# EIGHTEEN SUNSET

DESIGN REVIEW BOARD

FINAL SUBMITTAL JANUARY 4, 2021

DESIGN REVIEW BOARD *PROPOSED*

# EAST ELEVATION (BAY) PROPOSED

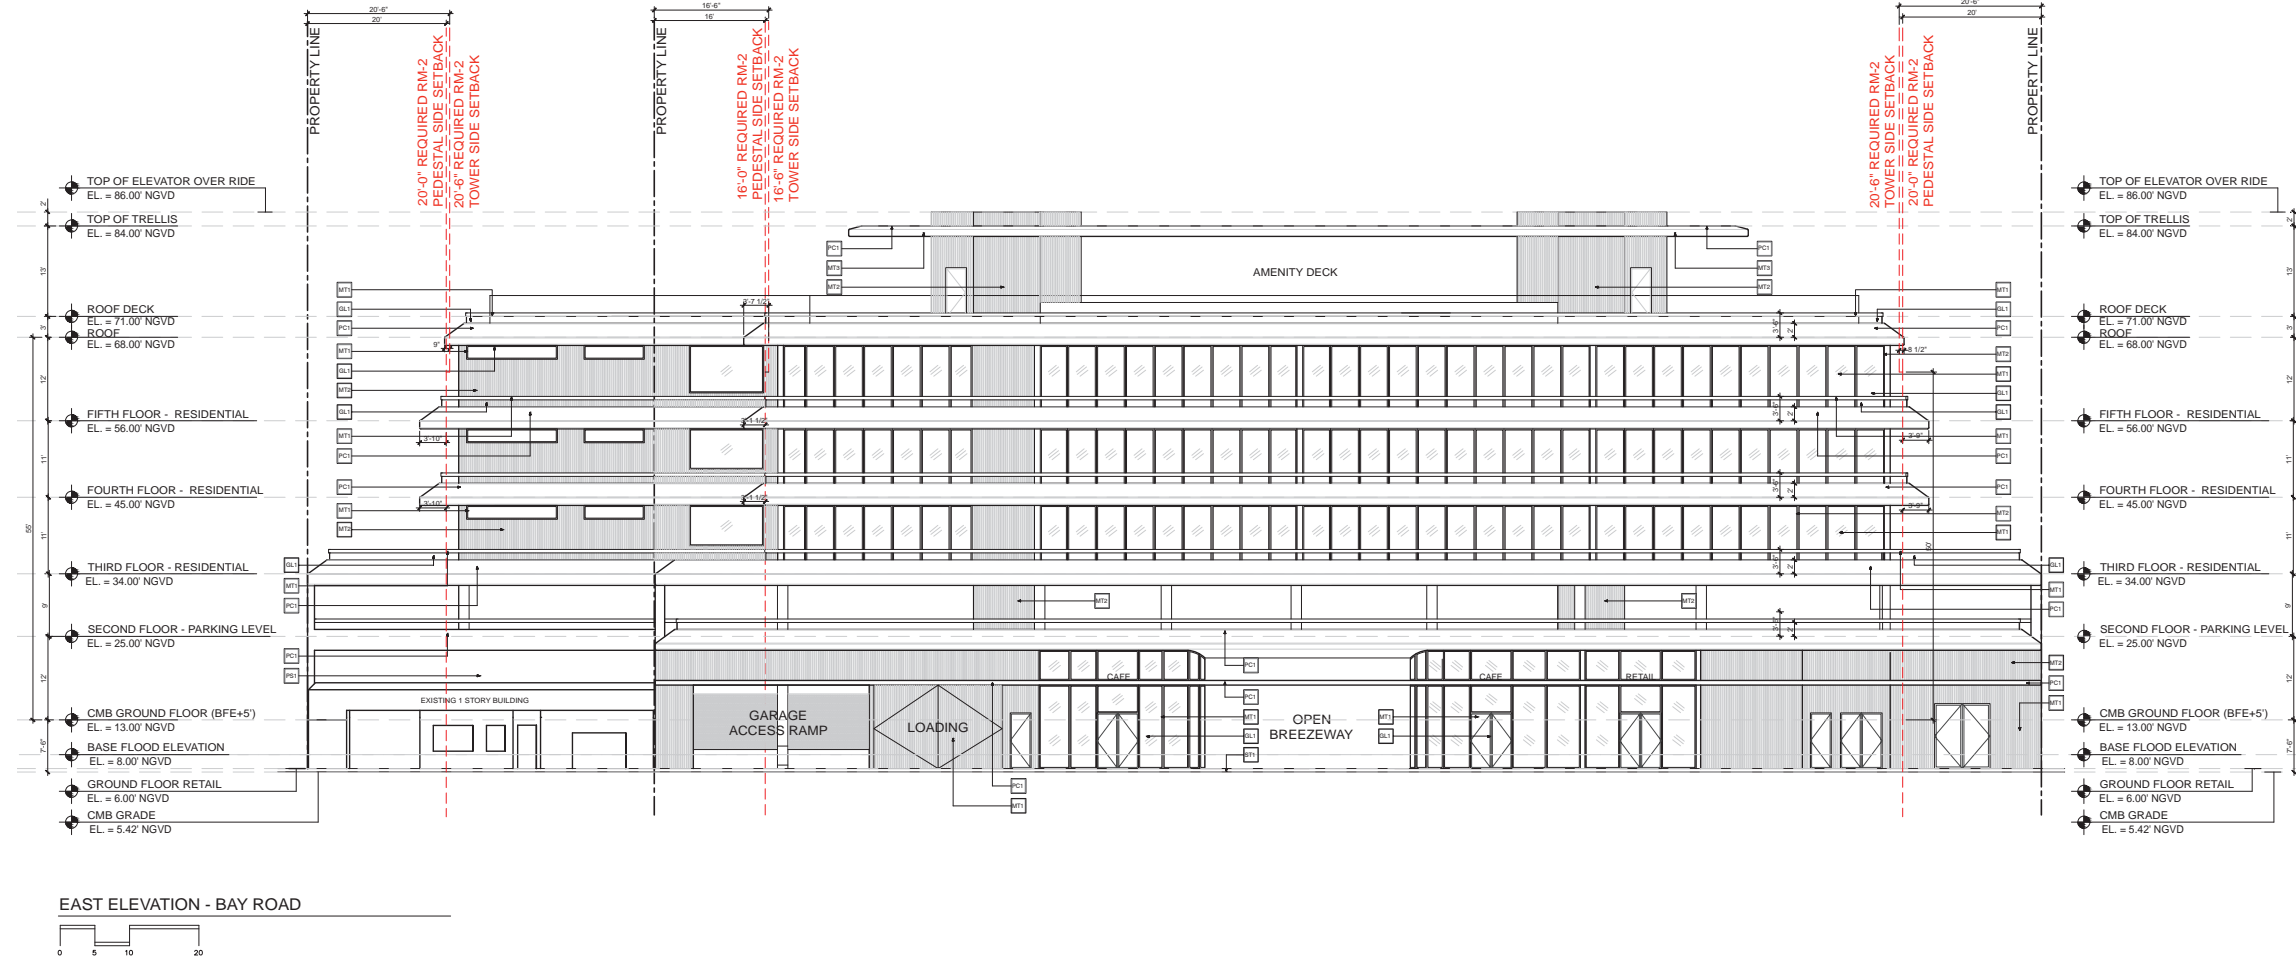
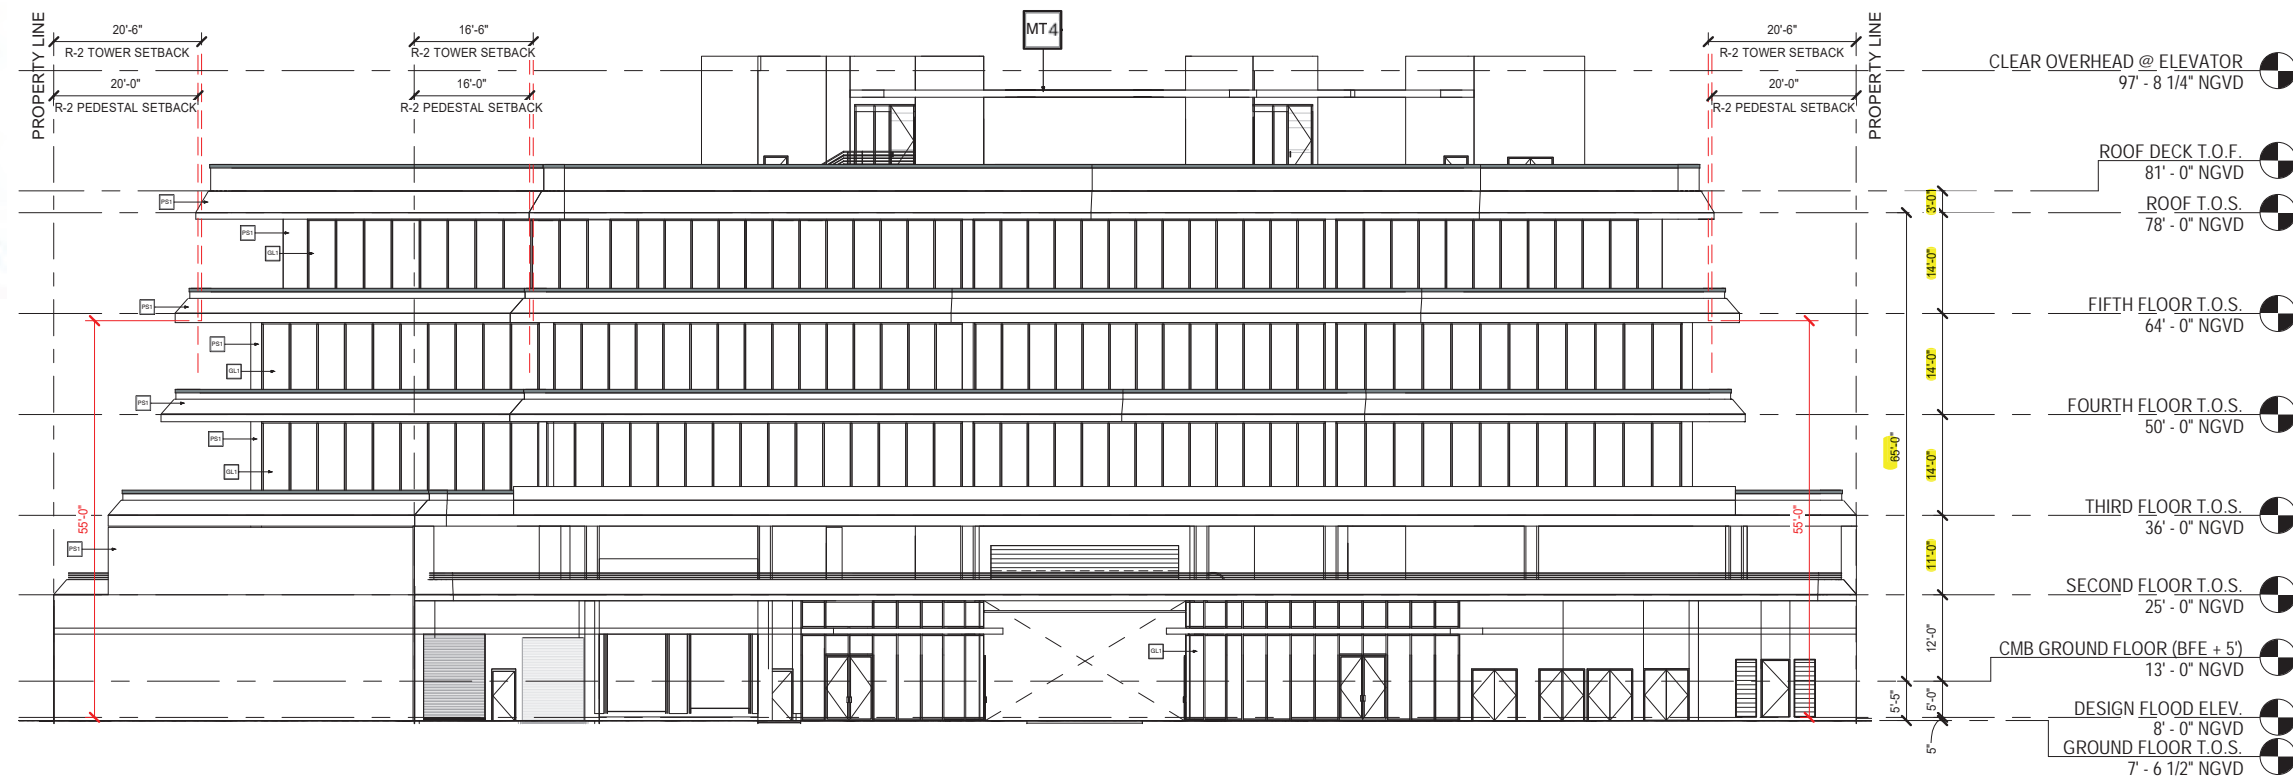
ALL MATERIALS ARE EITHER STUCCO OR GLASS  
EXCEPT ALUMINUM TRELLIS

# NORTH ELEVATION PROPOSED

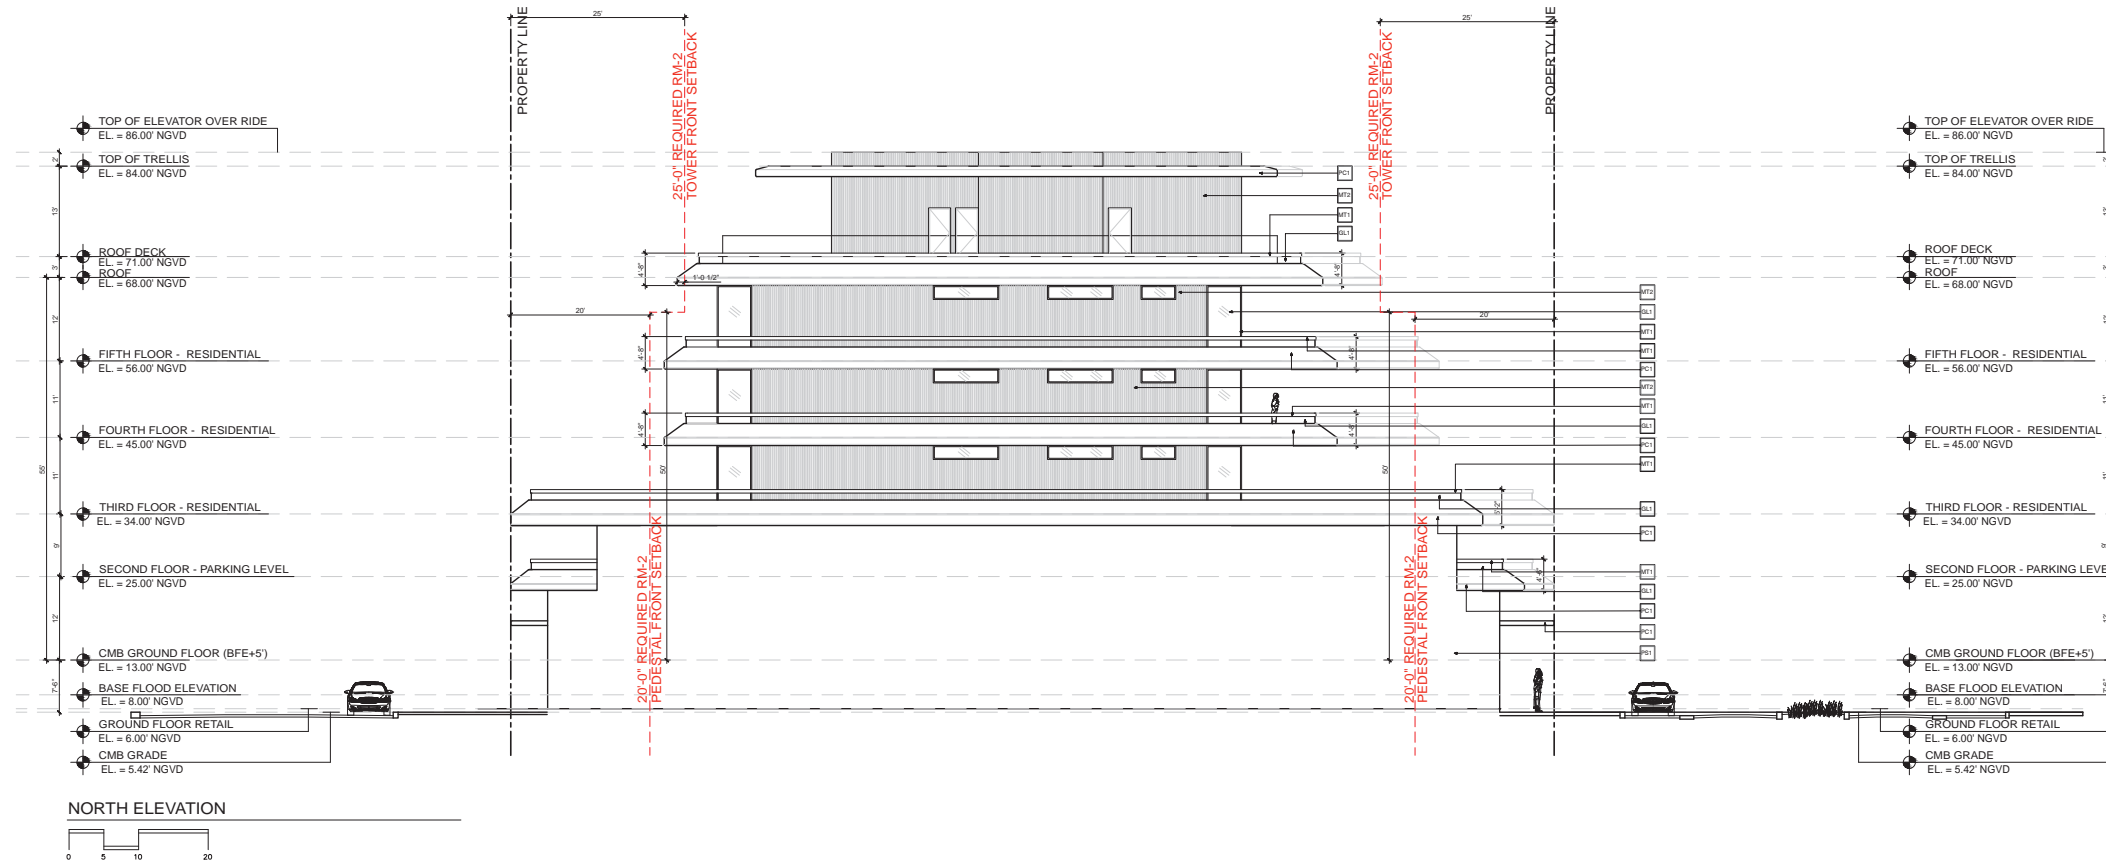
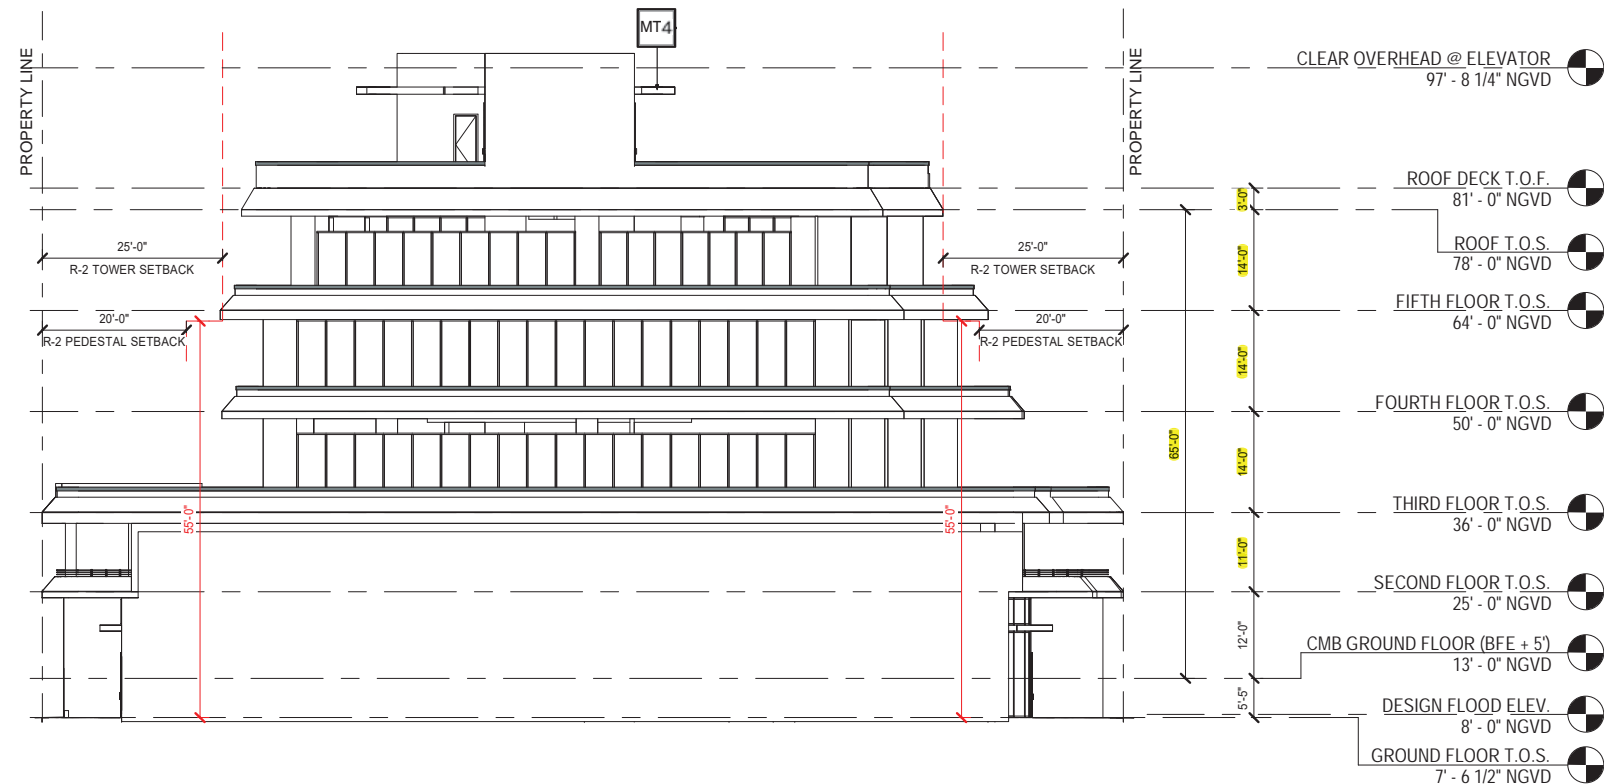
ALL MATERIALS ARE EITHER STUCCO OR GLASS  
EXCEPT ALUMINUM TRELLIS

# SOUTH ELEVATION PROPOSED

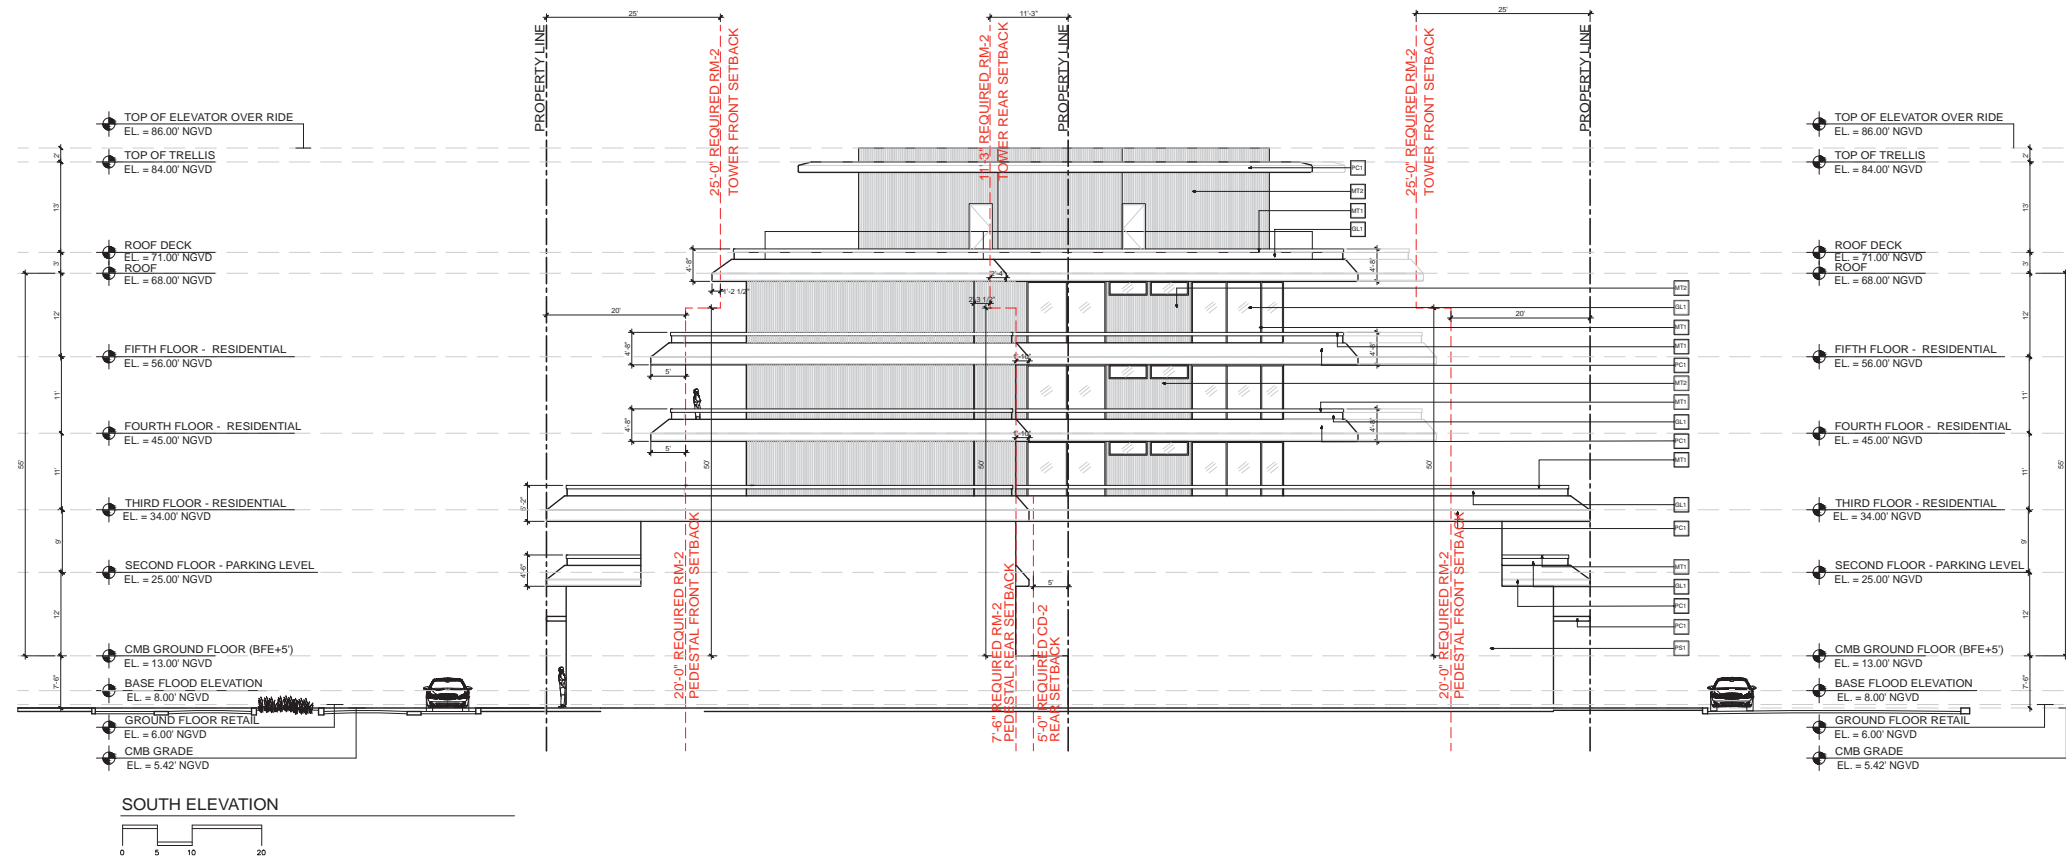
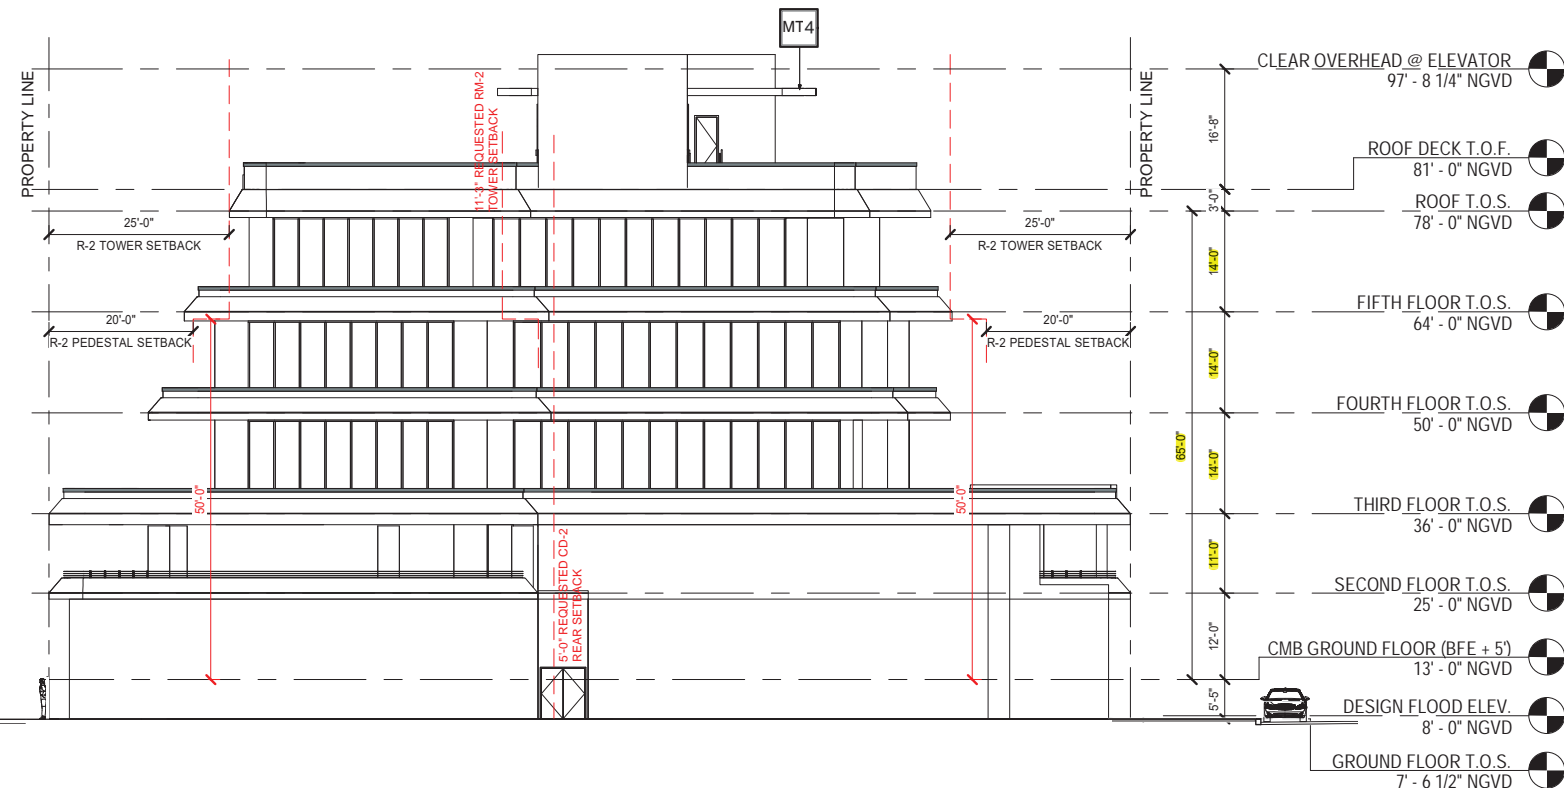
ALL MATERIALS ARE EITHER STUCCO OR GLASS  
EXCEPT ALUMINUM TRELLIS
